KURT ALLEN FISHER P.O.B. 11753 Salt Lake City, Utah 84147-0753 fisherka@csolutions.net (801) 414-1607 (cell) June 12, 2019

Re: Is Moving the 4th Ave Well a Feasible Alternative? General Comments to the Salt Lake City Council

Figure 2 – Assessor Parcel Map Near North Temple and State Streets

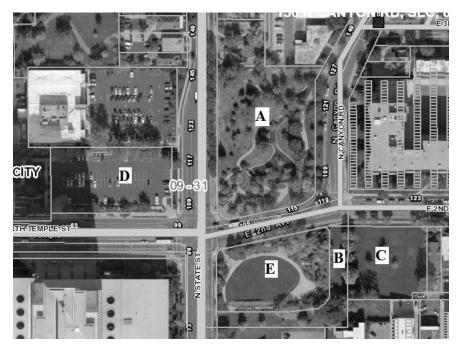
Figure 2 show several parcels to the south of 200 North Canyon Road near State and North Temple per the Salt Lake County Assessor's Office.¹⁹ Table 1 describes those parcel and Table 2 estimates acquisition costs based on assessor records. Parcel A is owned by Salt Lake City Corporation and has no cost. Parcel "D" is owned by the Church who might be approached to donate a portion of their land's values considering their extensive experience. Although Parcel "B" is privately owned and its irregular shape lends it to be desirable for a developer to sell. Parcel "E" is excluded as a possible alternative because its size is insufficient to accommodate a one-quarter acre facility.

As shown in Table 2, the DPU's conclusion that no property is available or could not be purchased at a reasonable price appears to warrant further review in the future administration report on alternatives.
